**Re: Carlsbad Energy Center Project (07-AFC-6)
Data Responses, Set 3A
(Responses to Data Requests 126 through 131)**

APPLICATION FOR CERTIFICATION
FOR THE **CARLSBAD ENERGY CENTER
PROJECT**

Data Responses, Set 3A

(Responses to Data Requests 126 through 131)

FIGURE 1.
CULTURAL RESOURCES
SURVEY AREA
 CARLSBAD ENERGY CENTER PROJECT
 CARLSBAD, CALIFORNIA

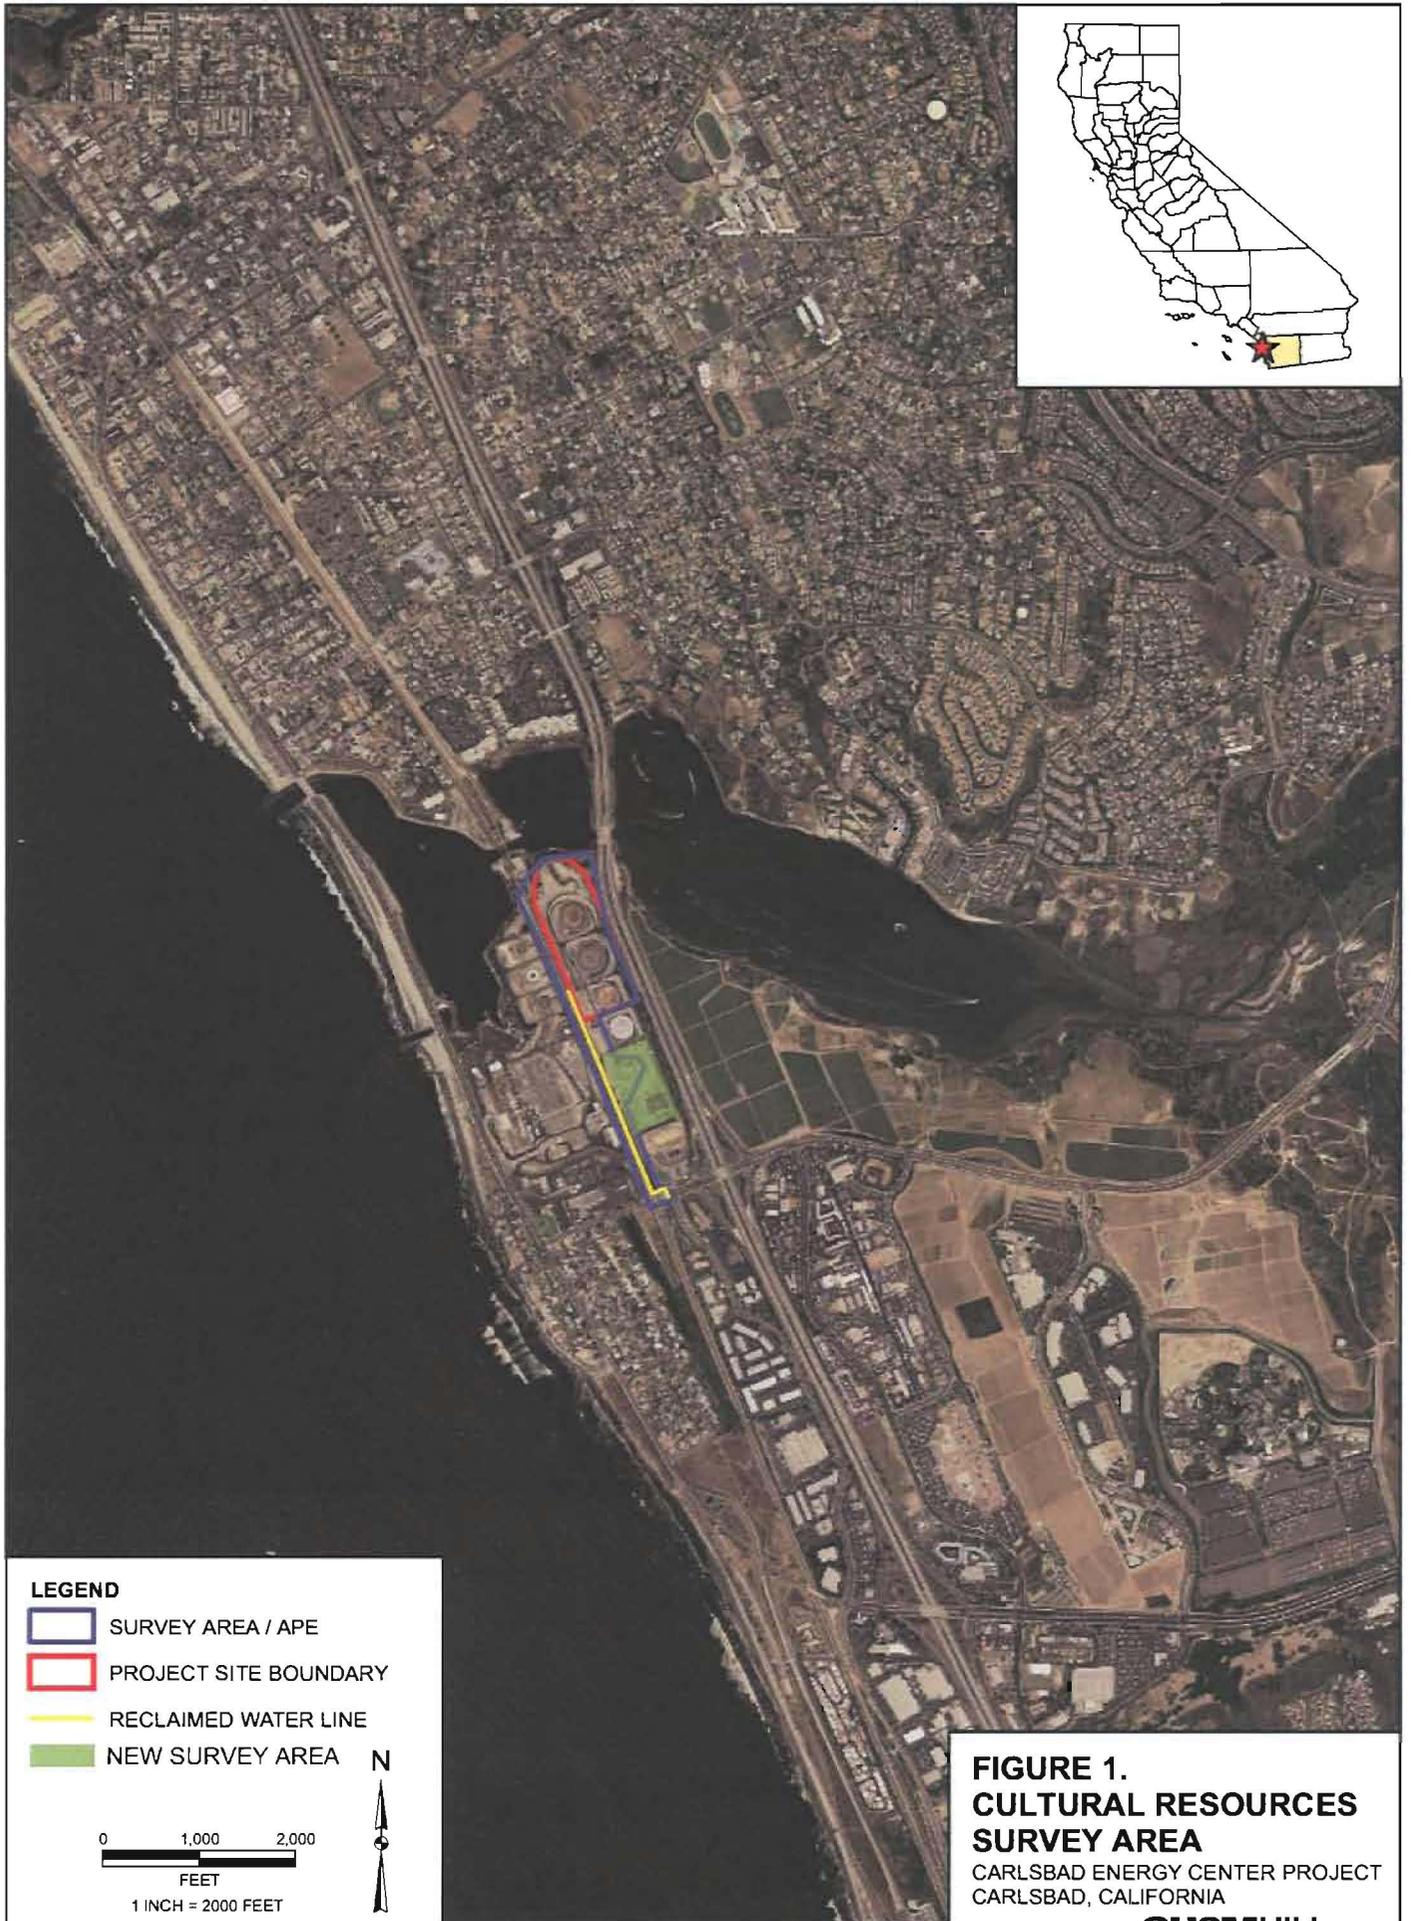
128. Please provide a figure similar in scale to AFC Figure 5.3-2 that identifies the cultural resources survey area in relation to the proposed enhancements and refinements.

A new figure depicting the additional survey area has been included with the Follow-on Cultural Resources Assessment (see Attachment DR 127A).
